Plan Commission

Agenda

Monday, September 23, 2019

Request For Plan Commission Action

UTILITY PLAN

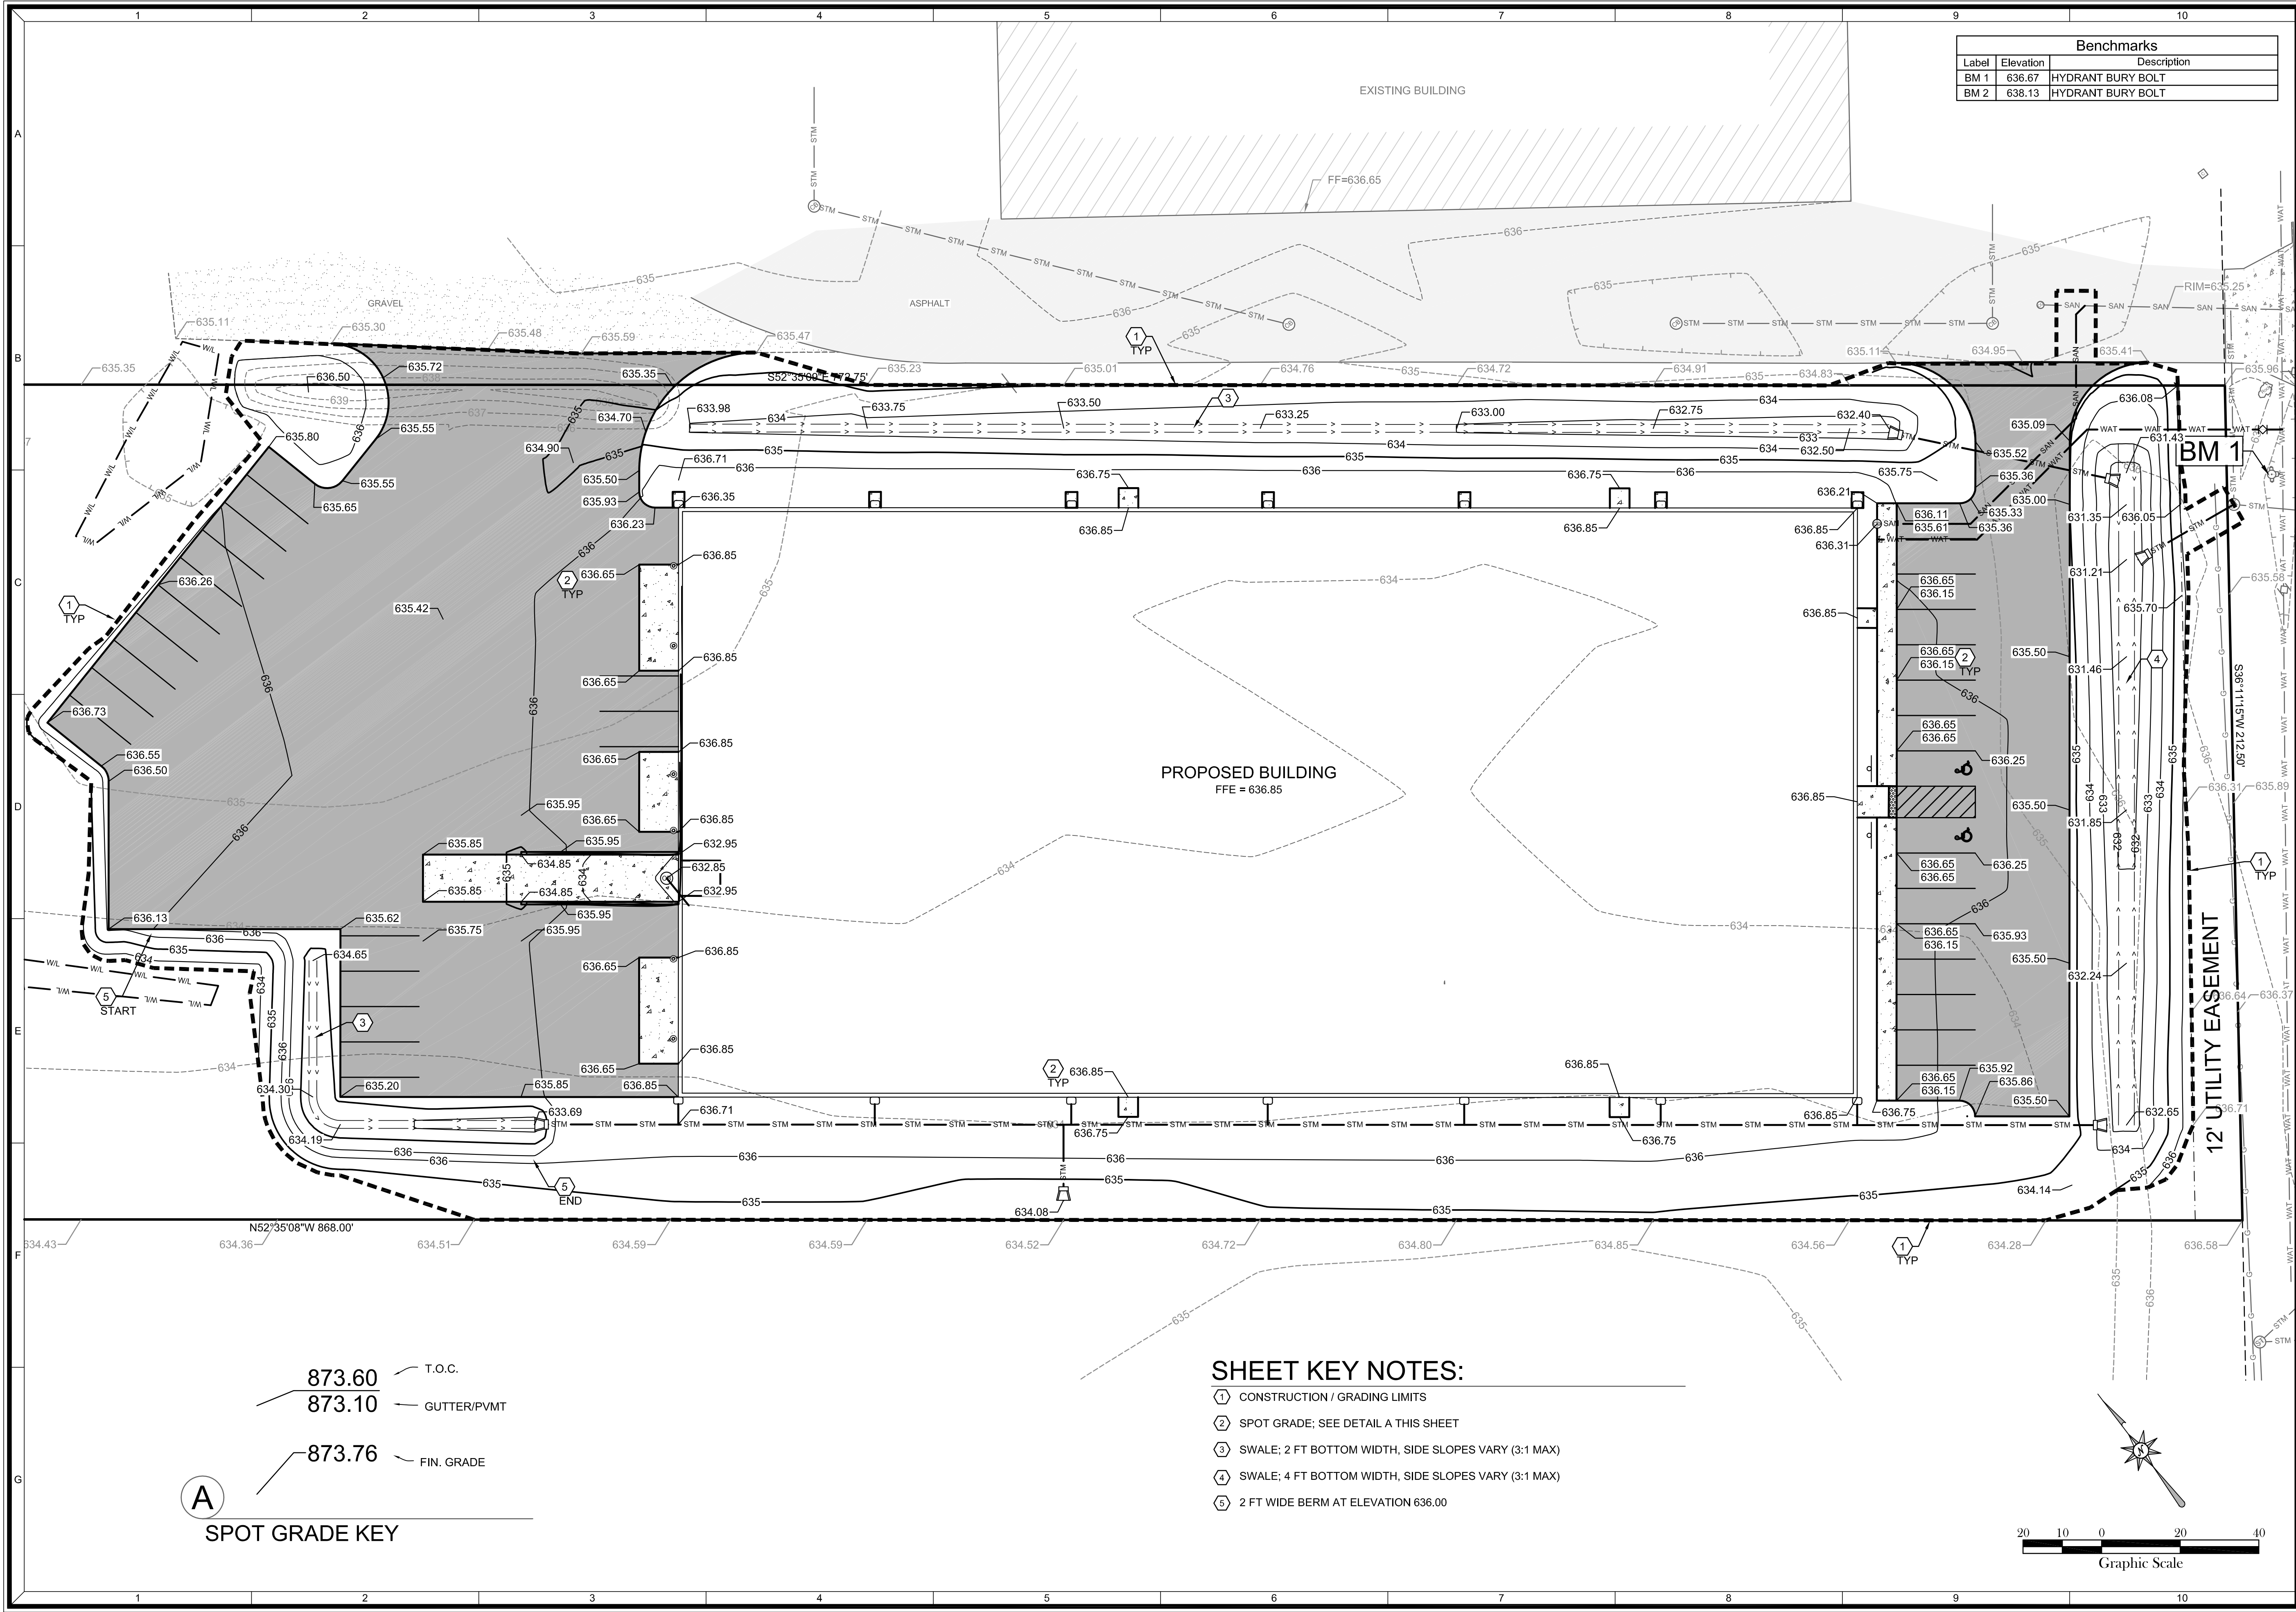
10. Sheet C3.0: Please indicate if you are choosing to combine the sanitary lateral with the property to the north, an agreement would need to be recorded for the maintenance of this sanitary sewer connection should it be required. This comment is resolved if the parcels are being combined. **Both parcel will be under same ownership. Location of sanitary easement has added to plan. Easement to be recorded if required.**

11. Sheet C3.0: Storm sewer work on adjacent property to the south would not be permitted. It is possible for this be directed to newly constructed ditch to the east of building. Please indicate if that is the route you wish to take. **Grading on property to south has been eliminated**

12. Sheet C3.0: Indicate water meter size. One month advance notice is required for water meters larger than 1-inch so they can be special ordered. **Water meter size to be determined by building plumbing designer.**
